534 Delaware Ave, Suite 302  
Buffalo, NY 14202  
January 31, 2017

Re: Additional comments on DEC Application ID#0-9999-00075/00001 (Cargill Mine Shaft #4)

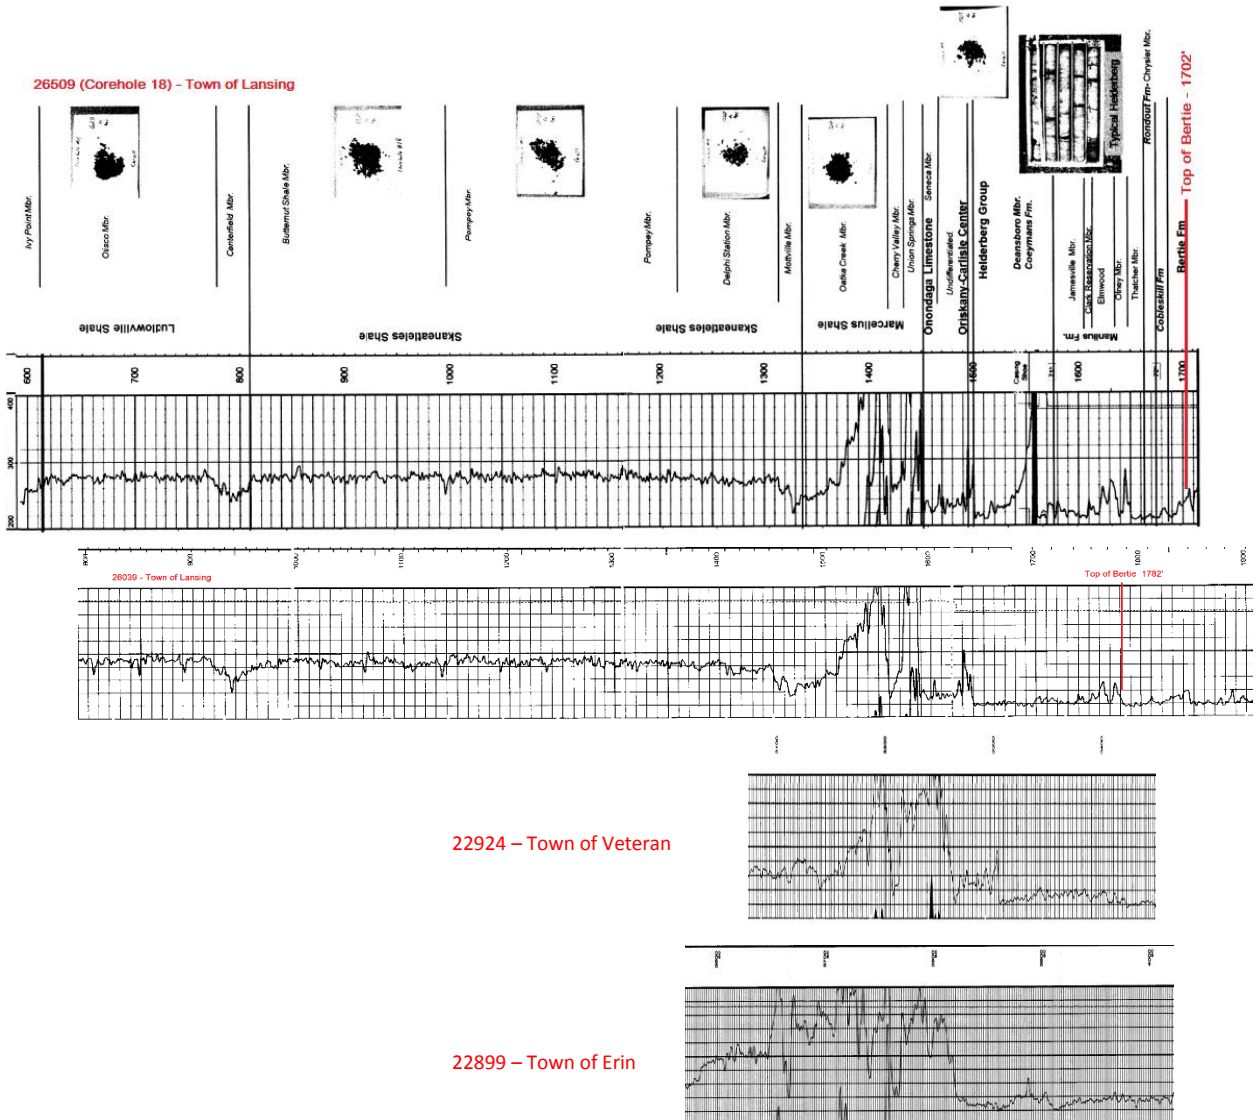
The evidence for a repeated section and intersecting fault in Corehole 18 is the unexplained gamma spike which rises from about 20 API units to about 200 API units in the depth interval from about 1510 to 1555 feet on the gamma log for Corehole 18 (API well no. 31-109-26509). See Figs. 1-2 (attached), and see also p. 23 and Appendix C of the November 2013 report by RESPEC, *Cargill Deicing Technology Lansing Mine, Corehole #18 Stratigraphic Test Hole, Installation and Data Collection*, Topical Report RSI-2381.

Alternatively, RESPEC interprets this interval as part of the Helderberg Group, including the Deansboro Member of the Coeymans Formation. See Fig. 1 (attached) and RESPEC, op. cit., 16-25. This interpretation is stratigraphically plausible and does not involve any repeated section or fault. The problem with this interpretation is that a strong gamma spike is not characteristic of the Deansboro Member and/or the Coeymans Formation. These units are limestones, as indicated, for example, by J.N. Berdan, *The Helderberg Group and the Position of the Silurian-Devonian Boundary in North America*, USGS Bulletin 1180-B (1964), Fig. 2. Strong gamma spikes are typically associated with black shales but not with limestones.

Comparisons can also be made to other wells that penetrate the Coeymans Formation. Such comparisons do not show a strong gamma spike at or near the interval where the Coeymans is present. Logs for two such wells are shown in Fig. 1. Both wells are known to penetrate the Coeymans Fm.: see January 2005 report by New York State Museum, *Systematic Technical Innovations Initiative, Brine Disposal in the Northeast*, DE-FC26-01NT41298, Fig. 13b (and note that Table 3 of Appendix A could provide other examples, and see also Fig. 9 for another well that penetrates undifferentiated Helderberg strata). Comparisons cannot be made to other, closer wells around Borehole 18 because the Coeymans Fm. is absent in these wells (e.g., 31-109-26039 in Lansing, 31-011-26027 in Ledyard, 31-011-23840 in Genoa, and 31-109-22867 in Dryden).

An unexplained gamma spike may seem a small matter – but wireline logging of oil and gas wells is a mature technology, and an unexplained gamma spike of this magnitude cannot simply be dismissed. Without a good explanation of this gamma spike, *further investigation is needed to characterize or rule out the repeated section and fault implied by the gamma spike*. The issue is complicated by the location of the casing shoe at about 1553' depth in Corehole 18, but a gamma spike of this magnitude is generally not associated with casing. Residual drilling mud may also affect gamma readings (for example, see [http://petrowiki.org/Gamma\\_ray\\_logs](http://petrowiki.org/Gamma_ray_logs)), but even if mud were used in drilling/coring the different stages of this hole, is not clear how this could affect the gamma counts over tens of feet of vertical distance in the well. As noted, the gamma spike gradually rises from about 20 API units to about 200 API units in the depth interval from about 1510 to 1555 feet.

In summary, further investigation is needed to characterize or rule out the repeated section and fault implied by the strong gamma spike seen on the Corehole 18 logs.

**Fig. 2:** Relevant interval of Corehole 18 log, from Weatherford Photo Density/Compensated Neutron/Gamma Ray log, August 20, 2013, 5-inch main log.

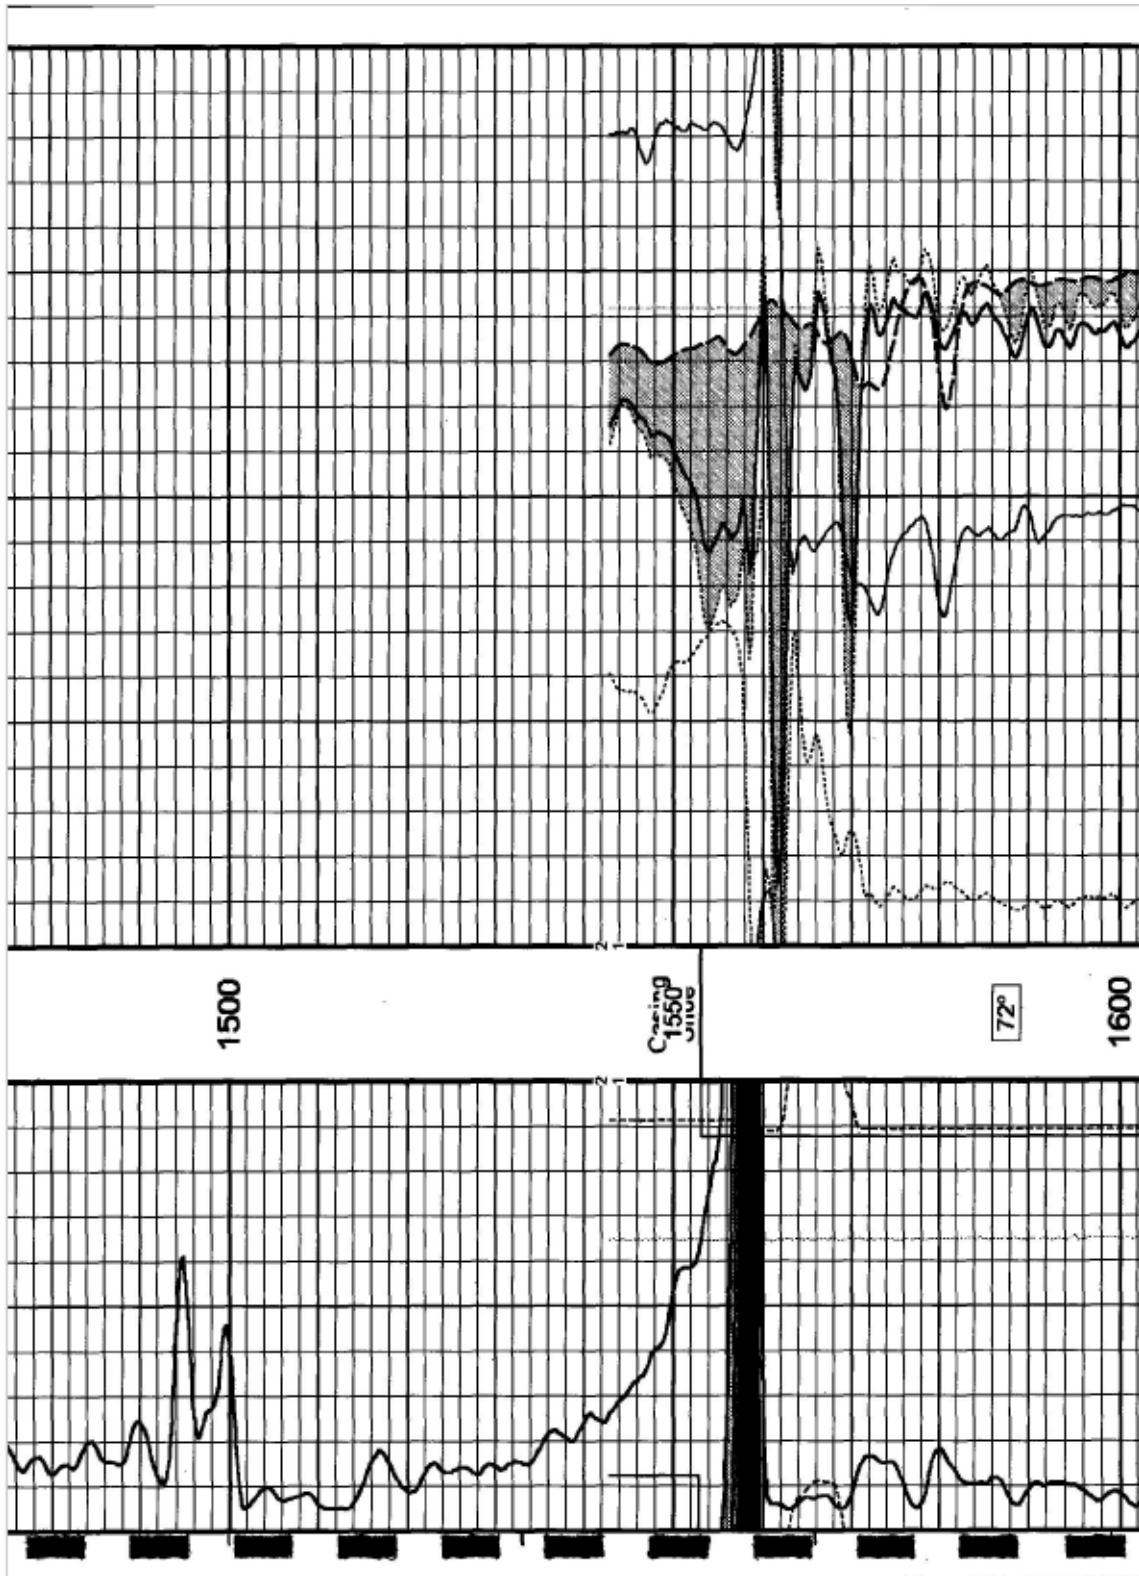
The interval in question (from about 1510 to 1555 feet depth) appears to be a repeated section of overlying strata which would indicate that a fault intersects the well bore.
